Our Ref L.448.033.EE

Proposal: Application under Section 96a of the Town and County Planning Act 1990 (as amended) to make non-material amendments to permission 200188 (allowed on appeal under APP/E0345/W/21/3276463 on 17/03/2022) for Demolition of existing structures and erection of a series of buildings ranging in height from 1 to 11 storeys, including residential dwellings (C3 use class) and retail floorspace (A3 use class), together with a new north-south pedestrian link, connecting Christchurch Bridge to Vastern Road), including an increase from 4 to 5 storeys of the western wing of Block B, amendments to the top two floors of Blocks D & E, changes to the unit mix and various other associated alterations (amended description) as approved under App. Ref. 231673 (from 27th March 2024), to amend the drawings listed under condition 47.

Location: 55 Vastern Road, Reading, RG1 8BU.

Approved drawings
vs.
now proposed drawings

Eighth Floor
1:500

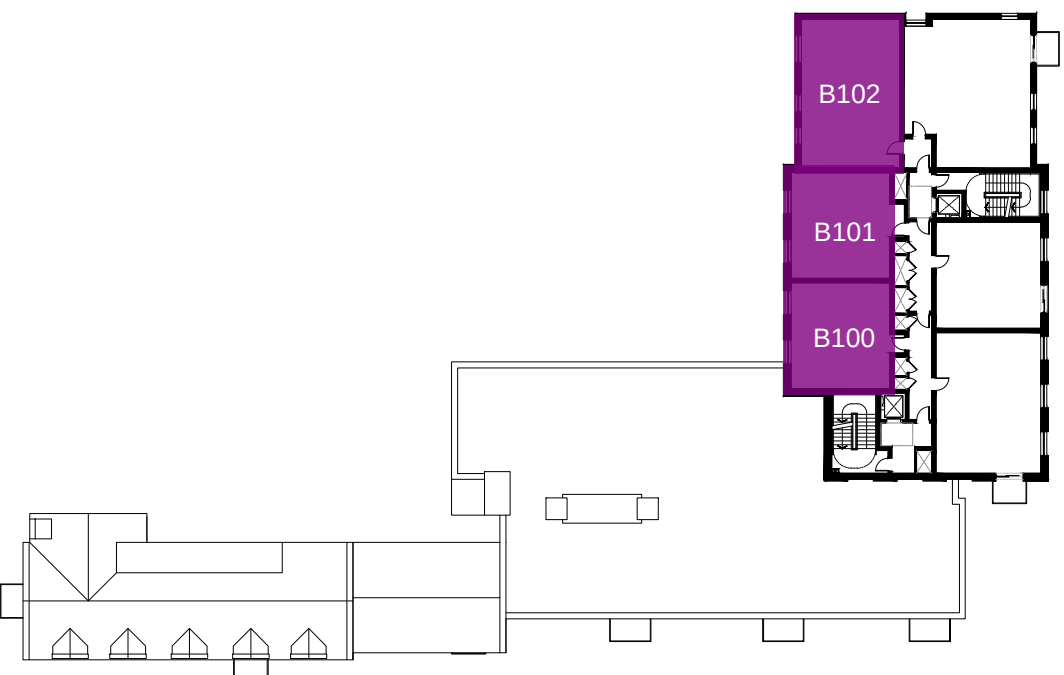
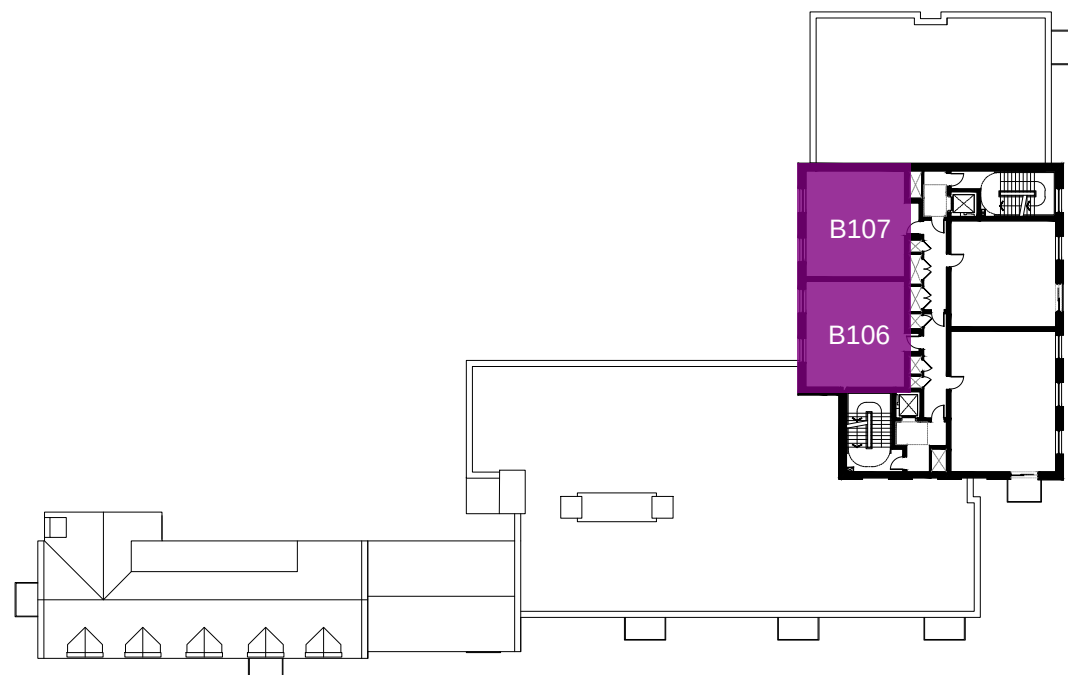
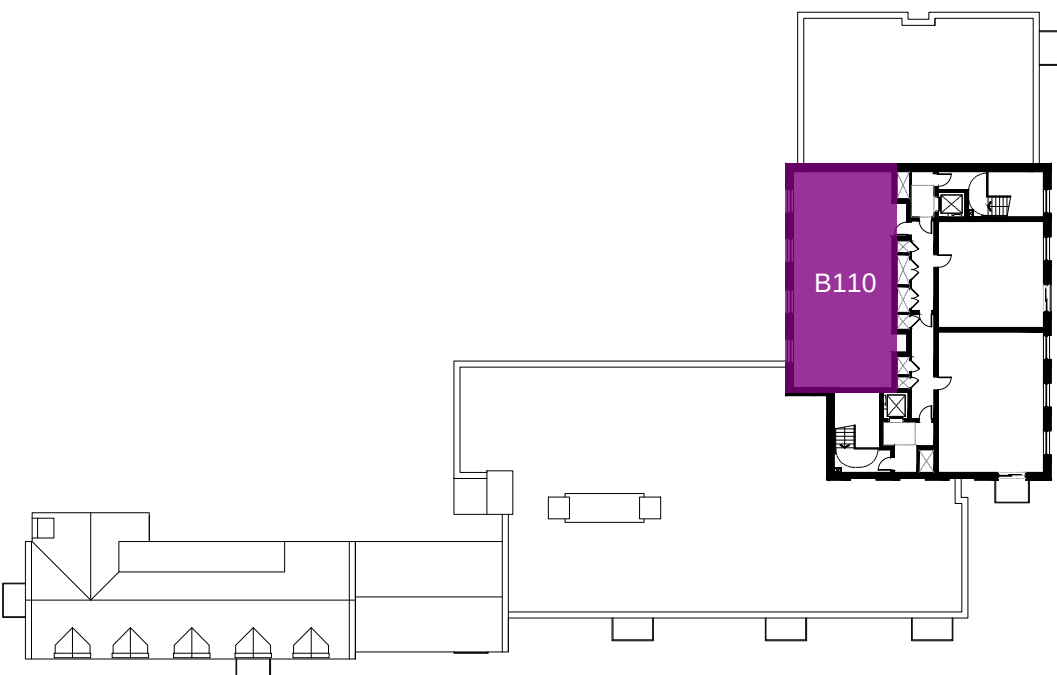
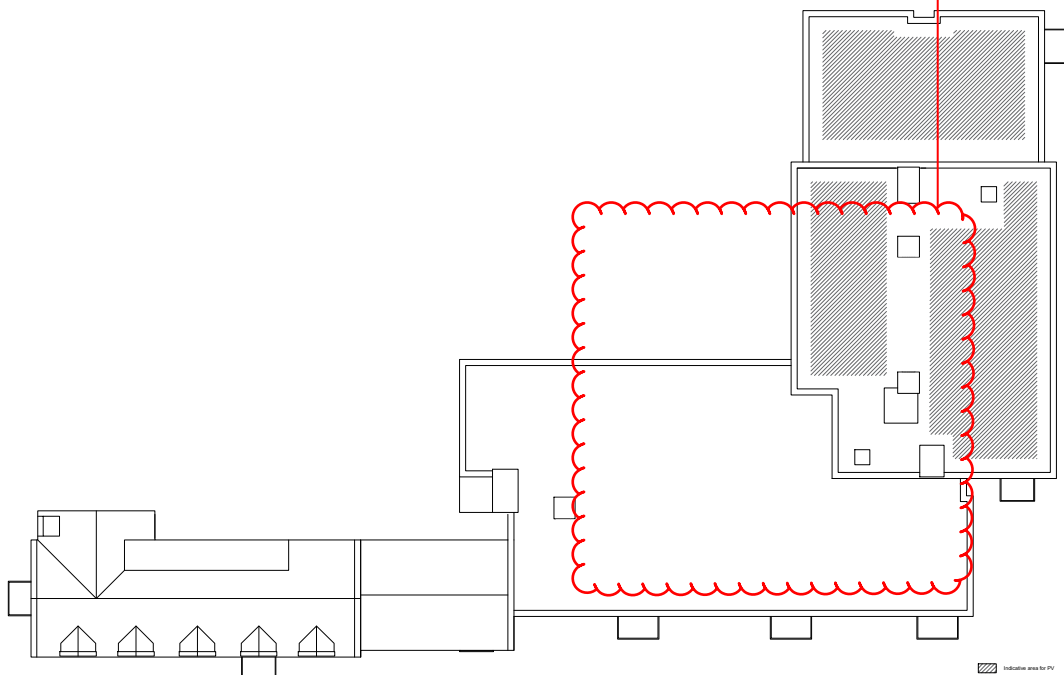
Triple Glazing:
9.5mm glass - 6mm airgap - 4mm glass -14mm airgap - 4mm glass
Secondary Glazing:
200mm airgap - 8.8mm acoustic laminated glass
Ventilation:
All atmospheric termination on the roof.
No atmospheric termination on the facade.

Triple Glazing:
9.5mm glass - 6mm airgap - 4mm glass -14mm airgap - 4mm glass
Secondary Glazing:
200mm airgap 6mm acoustic laminated glass
Ventilation:
No atmospheric termination on the roof.
All atmospheric termination on the facade.

Glazing thickness updated

roof equipment omitted
as not required

Drawing Name	Approved drawing reference:	Changing to:	Amendment
Block B and C			
MVHR Proposal Glazing and Ventilation Plans	448.PL.BC.V.100.B	448.PL.BC.V.100.C	Glazing thickness updated in line with the report R10314-22 Rev 0
MVHR Proposal First Floor Plan	448.PL.BC.V.101.B	448.PL.BC.V.101.C	Ventilation ducting updated.
MVHR Proposal Second Floor Plan	448.PL.BC.V.102.B	448.PL.BC.V.102.C	Ventilation ducting updated.
MVHR Proposal Third Floor Plan	448.PL.BC.V.103.B	448.PL.BC.V.103.C	Ventilation ducting updated.
MVHR Proposal Fourth Floor Plan	448.PL.BC.V.104.B	448.PL.BC.V.104.C	Ventilation ducting updated.
MVHR Proposal Fifth Floor Plan	448.PL.BC.V.105.B	448.PL.BC.V.105.C	Ventilation ducting updated.
MVHR Proposal Sixth Floor Plan	448.PL.BC.V.106.B	448.PL.BC.V.106.C	Ventilation ducting updated.
MVHR Proposal Seventh Floor Plan	448.PL.BC.V.107.B	448.PL.BC.V.107.C	Ventilation ducting updated.
MVHR Proposal Eighth Floor Plan	448.PL.BC.V.108.B	448.PL.BC.V.108.C	Ventilation ducting updated.
